ADDRESSEES	: Owners and operators of coaches listed under "Application" ABC Customer Care and Parts Source
VEHICLE MODEL	: TDX25E
MANUAL SECTION	: 08.02 Climate control – control system
BULLETIN TYPE	: Field Change Program
DATE	: December 20th, 2022
SUBJECT	: Optimization of driver's cab climate control system operation
TERMS & CONDITIONS	: Refer to the warranty section further in this Bulletin.

To address this issue, Van Hool is conducting a Field Change Program at which the existing potentiometer control must be replaced by one with a different resistance curve. Additionally some small modifications with respect to resistors must be made in junction boxes EK1 and EK2. Follow the step-by-step instructions in this service bulletin about this. From VIN 89508 onwards, the vehicles are manufactured according to the new set-up.

Figure 1: Temperature control (potentiometer) of driver's cab control system

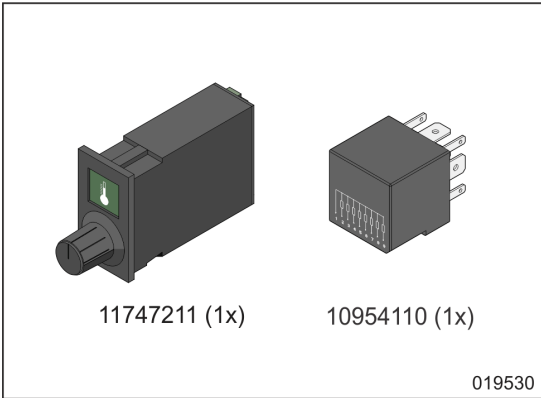
Van Hool have received some complaints about the temperature control for the driver's cab. Investigation has shown that some vehicles have left the factory with an incorrect dashboard potentiometer temperature control.
